UNITED STATES PATENT AND TRADEMARK OFFICE

APPLICATION NO.	FILING DATE	FIRST NAMED INVENTOR	ATTORNEY DOCKET NO.	CONFIRMATION NO.
09/720,744	06/11/2001	Wilmert De Bosscher	522-1730	5005

Office Action Summary	Application No.	Applicant(s)	
	09/720,744	BOSSCHER ET AL.	
	Examiner	Art Unit	
	Aaron M Dunwoody	3679

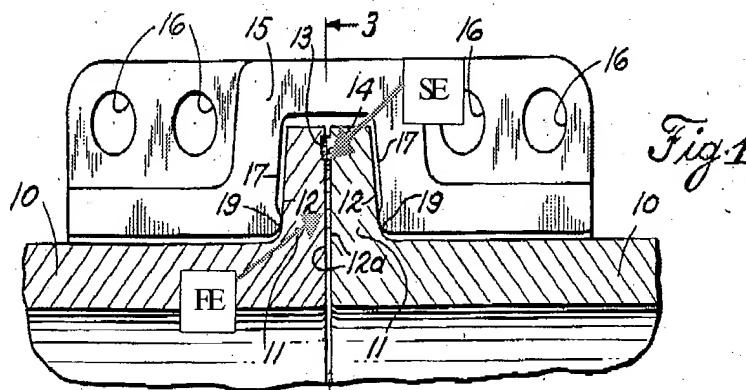
In regards to claim 13, in Figure 1 below, Hobbs discloses a vacuum tight coupling for end portions of two tubular sections, a portion of the two tubular sections having an inner space (relative to the outer circumference of each tubular section), the size of the inner space of a first end portion (FE) being smaller than that of a second end portion (SE),

the second end portion having a flange extremity axially slidable over the first end portion to abut the flange extremity against a peripheral outer abutment ring on the first end portion, the coupling comprising at least one sealing ring (13) located between an

inwardly facing surface of the second end portion and an outwardly facing surface of the first end portion in a sliding overlapping contact area and further comprising a clamping ring (15) with a substantially cylindrical outer surface and being of composed clamping elements (col. 3, lines 21-23), each clamp having a semi-circular or U-shaped cross section with an inwardly oriented recess, the recess enclosing the flange extremity and the abutment ring, the recess cooperating with the flange extremities to positively, solidly and axially clamp the abutment ring against the flange extremity, the clamping elements being fixed to each other at their extremities with fixing means comprising in at least one place on the clamping ring bolting means, the axis of which is perpendicular to the longitudinal axis of the coupled tubular sections and substantially tangential to the clamping ring periphery.

In regards to claim 28, Hobbs discloses an anti-arcing element (27).
